Lloyd's Register of Shipping.

Ship's Name DURENDA

Memorandum of alterations reported since ship was surveyed for assignment of Load Lines
in JUNE, 1932.

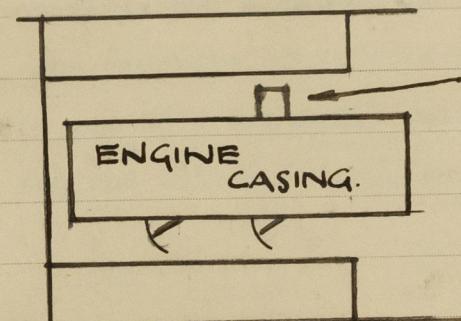
Reverse bars $3\frac{1}{2} \times 3\frac{1}{2} \times \frac{3}{8}$ are now fitted to the stiffeners
on each side of the bridge front openings (Lon. July, 1935).

BRIDGE
TWEEN
DECKHATCH 2'-0" x 2'-0", 9" RA. COAMING
TO STORE BELOW. $2\frac{1}{2}$ " COVERS 3" BEARING.
CLEATS AND TARPAULINS.
